# Assessment Officer Report

54-74 Southern Road,  
Mentone

Officer Assessment Report  
Development Approvals & Design

Key Information	Details
<b>Application No:</b>	PA2604228
<b>Received:</b>	<b>26 February 2026</b>
<b>Statutory Days:</b>	30
<b>Applicant:</b>	Veres Ida Asset Trust c/ Urbis
<b>Planning Scheme:</b>	Kingston
<b>Land Address:</b>	54-76 Southern Road, Mentone
<b>Proposal:</b>	Use and development of the subject site for the purpose of 12 warehouses with ancillary office spaces, an informal outdoor recreation space (i.e. public open space) plus a reduction in the provision of car parking and display of business identification signage.
<b>Development Value:</b>	\$ 44.9 million

**Figure 4: Distance to residential land**

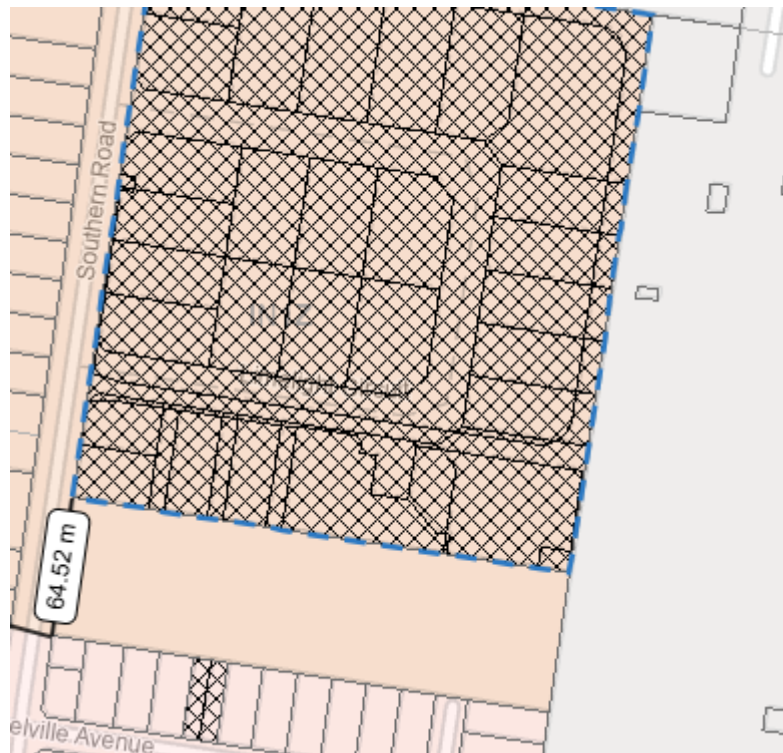
The site is approximately 64m from residential zoned land, and is distant from any of the other categories of land use (hospital, education centre, Public Acquisition Overlay to be acquired for a hospital or an education centre) and therefore meets the exemption outlined above.

Figure 5: Vehicle Access

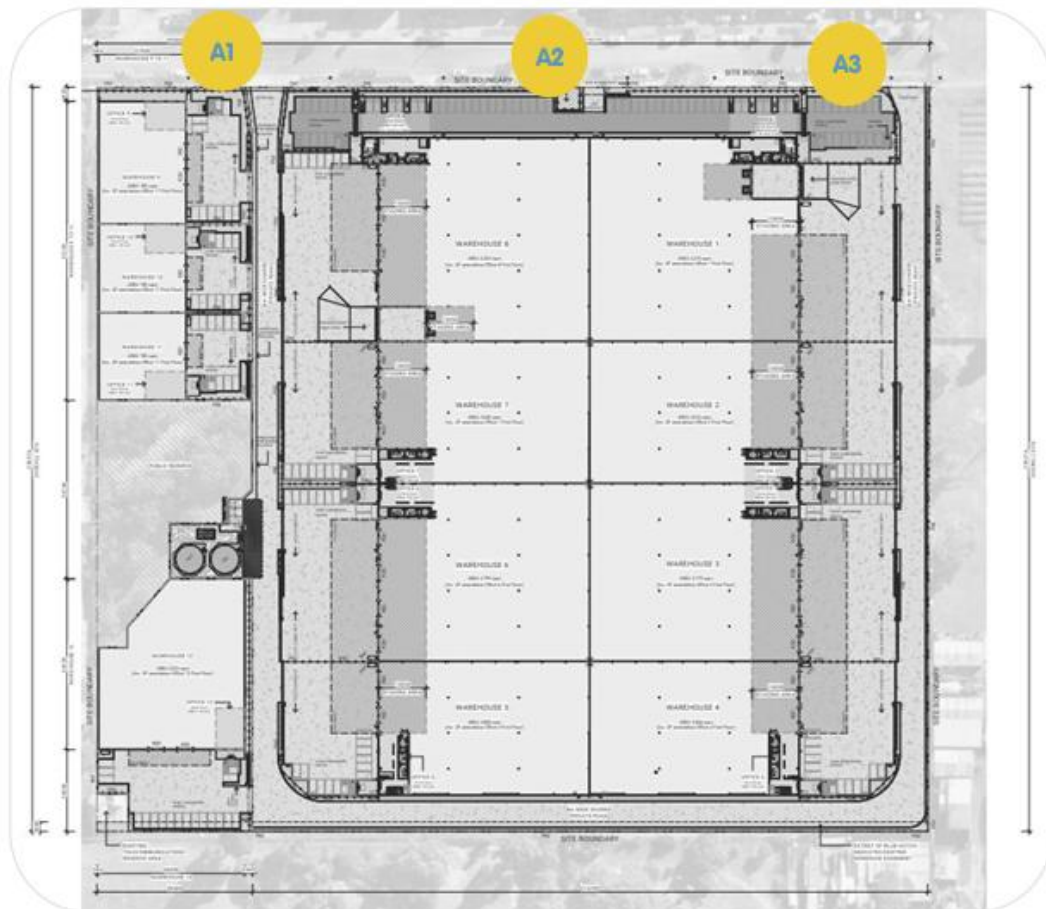
36. Council and nearby residential landowners have consistently identified interface issues between the industrial precinct and the residential area. These issues are primarily associated with heavy vehicle movements through the residential section of Southern Road.

37. In response to these concerns, Council recommended that consideration be given to establishing alternative connectivity via Commonwealth airport land to the north, with the intent of reducing industrial traffic impacts on the residential area.

42. While the Department supports Council's ongoing efforts to explore this option, DTP has not accepted the inclusion of the requested permit condition, noting that the permit applicant's traffic engineers have confirmed that the development has already been designed to accommodate any future northern access and therefore a condition to the effect is not required.
